## Sporting Bulletin n°2

**Date:** 29/11/2023

**Subject:** Throttle potentiometer sealing

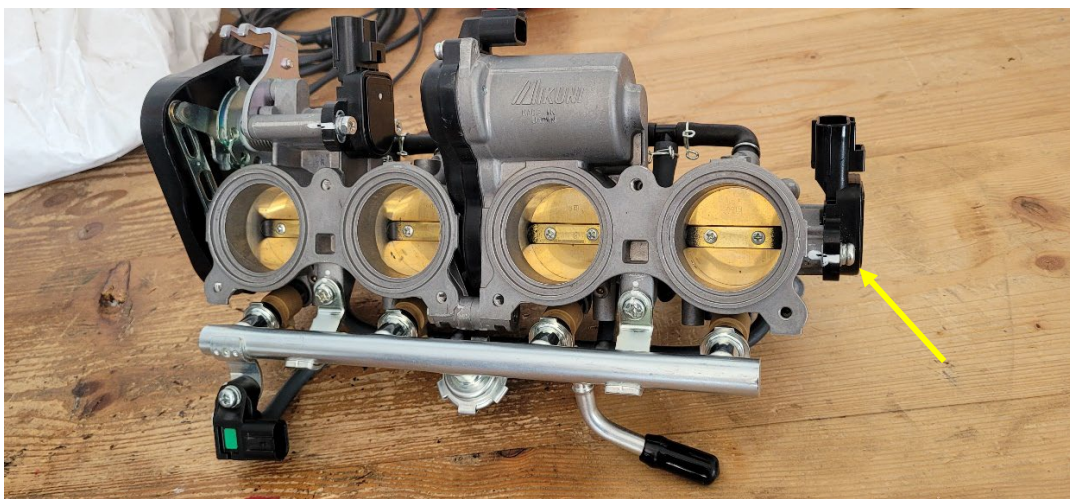
From the 2024 FIA European Cross Car Championship, the throttle potentiometer of the Yamaha R6 and MT09 engines must be prepared to be sealed during the pre-event scrutineering by the FIA technical delegate.

After the throttle learning control procedure and its validation by the FIA technical delegate, a seal for the throttle potentiometer fixing screw will be installed.

- Remove the marked screw,

- The teams must prepare this bolt with a 1 mm bore to be able to fit a 0.8 mm sealing wire.

- The team must reassemble the prepared bolt and install the 0.8 mm sealing wire.
- The FIA seal will be affixed and sealed by the FIA technical delegate.
